On behalf of the Department of Energy (DOE) and Sandia Corporation (Sandia), DOE is responding to the October 30, 2007 Notice of Approval: Monitoring Well Plug and Abandonment Plan and Replacement Well Construction Plan; Decommissioning of Groundwater Wells MWL-MW1 and MWL-MW3; MWL-MW7 and MWL-MW8, July 2007, Sandia National Laboratories, EPA ID No. NM5890110518, HWB-SNL-07-016. As detailed below, we have a number of concerns regarding the conditions of approval that define the locations of groundwater monitoring wells at the Mixed Waste Landfill (MWL).

**Document title: Response to Notice of Approval: Monitoring Well Plug and Abandonment Plan and Replacement Well Construction Plan; Decommissioning of Groundwater Monitoring Wells MWL-MW1 and MWL-MW3; Installation of Replacement Groundwater Monitoring Wells MWL-MW7 and MWL-MW8, July 2007 (HWB-SNL07-016) November 2007**

**Figure 1**  
**Location of Existing and Proposed Groundwater Monitoring Wells at the Mixed Waste Landfill**

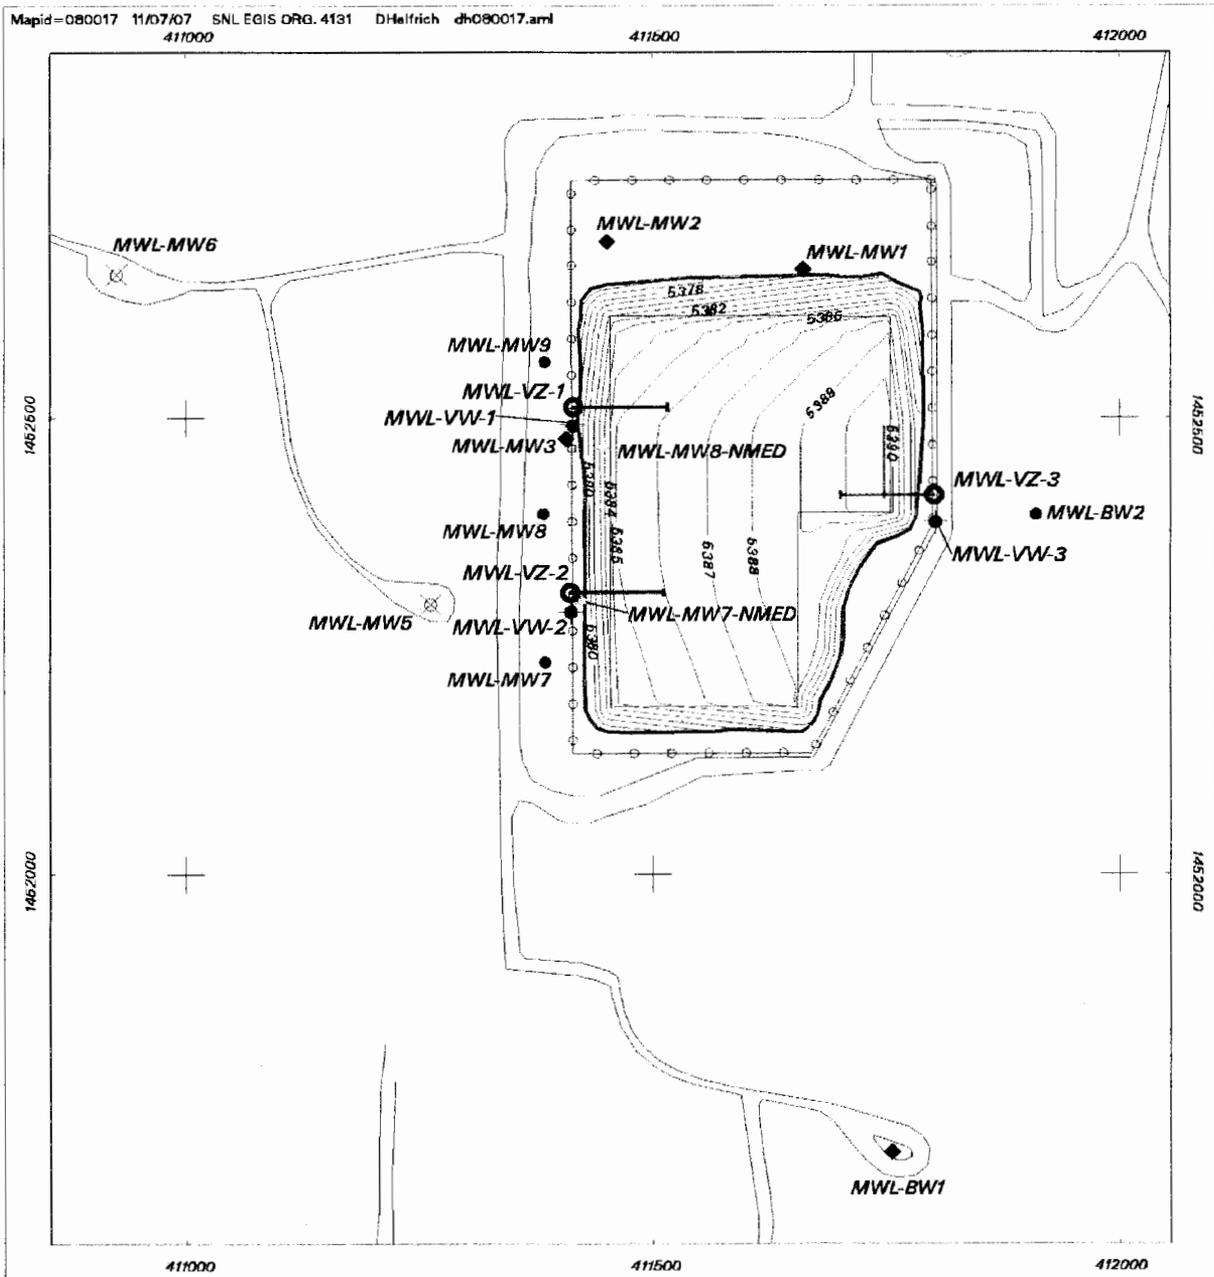
- *The proposed location of monitor well MWL-MW7 must be moved 80 feet at a bearing of 30° northeast from where it is shown on Figure 1 in the work plan.*
- *The proposed location of monitor well MWL-MW8 must be moved 100 feet at a bearing of 40° northeast.*
- *Both new wells shall be positioned as close as possible to the former west fence that originally surrounded the Mixed Waste Landfill.*

- **Structural Integrity and Performance of the Engineered Cover**--The NMED locations pose a threat to the integrity of the engineered cover. Placement of wells through the cover could result in preferential pathways for liquids over the long term. As noted on

Figure 1 from the work plan (see enclosure for revised Figure 1) the engineered topography of the cover slopes to the west. In order to protect the wellhead, the slope of the cover would need to be redesigned which would involve a significant effort and significant delays in implementing the remedy. While design changes could alleviate some concerns, such as protecting the wellhead, the potential for creating conduits over the long term remains a critical issue.

- **Structural Integrity and Performance of the Monitoring Wells**--If the wells are installed prior to the installation of the cover (as currently planned), the well casing would have to be extended to the new surface of the cover. In addition, the protective casing would have to be extended approximately 8 to 10 feet and the concrete pad and other surface completion features would have to be installed. Any disturbance to the well could compromise the integrity of the well. The revised completion on the cover would require re-survey of the critical monitoring well elevations. In addition, during the cover installation there will be significant traffic of heavy equipment in a very close proximity to the wellheads, again, affording an opportunity for damage.

- **Access and Security Issues**--DOE and Sandia proposed the locations of the wells to be just outside of the security fence that will be installed following cover completion. With this location outside the fence, there is no need for the sampling equipment truck to drive onto the cover to access the wells for sampling. The security plan specifies that only one gate will access the cover and that is on the north side. Driving across the cover would have the potential to cause damage to the crucial vegetation on the cover and to the integrity of the soil compaction that may lead to erosion.

- **Conflicts with the Monitoring Network Proposed in the LTMMP**--In the LTMMP (currently in NMED and public review) the DOE and Sandia proposed three wells on the western side of the landfill (outside of the security fence) to replace current monitoring wells, MWL-MW-1, -2, and -3. These three wells (MWL-MW-7, -8, and -9) are shown on Figure 3.5.1-1 in the LTMMP. The wells proposed in the LTMMP are evenly spaced along the western side of the landfill and represent downgradient points of compliance. The proposed NMED locations would significantly change this configuration. In addition, the NMED locations interfere with the neutron access tubes (already in place) and the locations for the soil-vapor sampling wells as proposed in the LTMMP. The two proposed soil-vapor wells located on the west side of the landfill are evenly spaced along the edge of the cover (Figure 3.4.1-1 in the LTMMP). Please refer to Figure 1 (enclosed), which includes all monitoring and soil-vapor well locations proposed in the LTMMP and the proposed NMED locations. DOE- and Sandia are currently preparing a plugging and abandonment plan for MWL-MW2 that includes the installation of MWL-MW9 at the location shown on Figure 1.

As DOE and Sandia believe the cited conditions will have the potential to affect the integrity of the MWL engineered cover over the long term and conflict with the groundwater monitoring well locations proposed in Long-Term Monitoring Maintenance Plan (LTMMP), DOE and Sandia respectfully request that NMED reconsider these conditions. DOE and Sandia detail the following reasons:
